Subject: Drainage Master Plan for the  
Herberger Property Development  
Zoning Case 93-Z-84

RESPONSES TO SEPTEMBER 12, 1985  
REVIEW COMMENTS ON HERBERGER MASTER DRAINAGE REPORT  
EAST OF SCOTTSDALE ROAD

MASTER DRAINAGE REPORT AND PLAN

SHEA SCOTTSDALE MASTER PLAN

# SHEA - SCOTTSDALE MASTER DRAINAGE PLAN

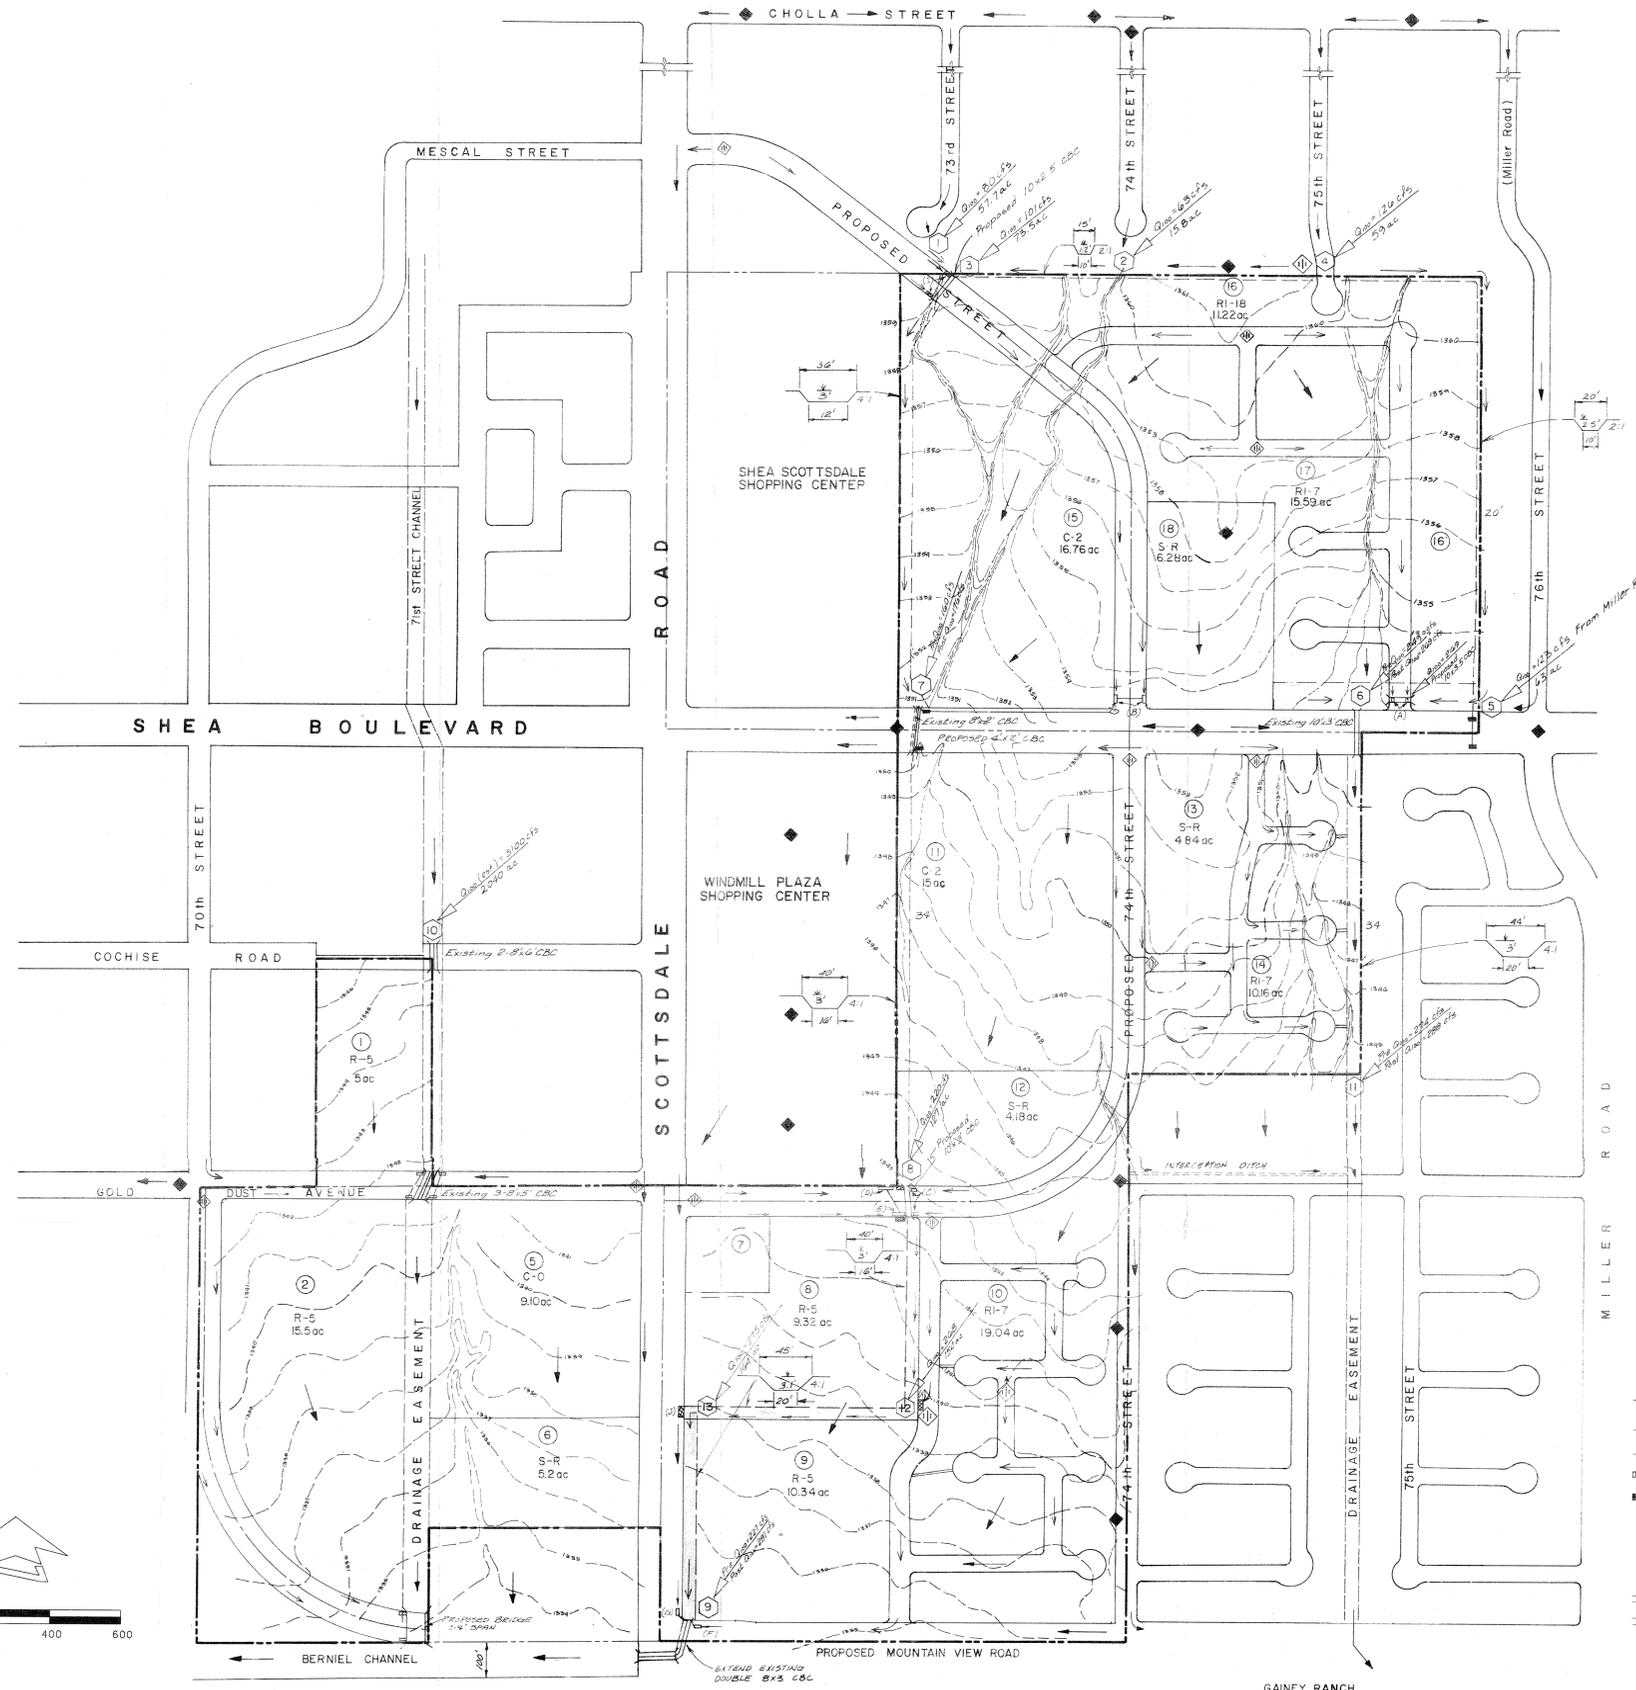
Enclosed is the Master Drainage Plan which accompanied the report you delivered to us on October 1, 1985. I have made comments in red concerning things which need to be addressed. In summary, these things are:

1. The channel side slope protection, and, in three locations, channel landscaping.
2. Two locations where I believe catch basins or scuppers are needed. ✓
3. The lack of information on catch basin size, type, and flow capacity ✓ calculations.

We have addressed the additional points brought out in your October 4, 1985, review. We have added to the Appendix: Section 4 on street drainage calculations and catch basin information as requested; a discussion of channel design assumptions discussing slope protection and landscaping following Section 2; and added scupper or catch basins where indicated on the drainage map.
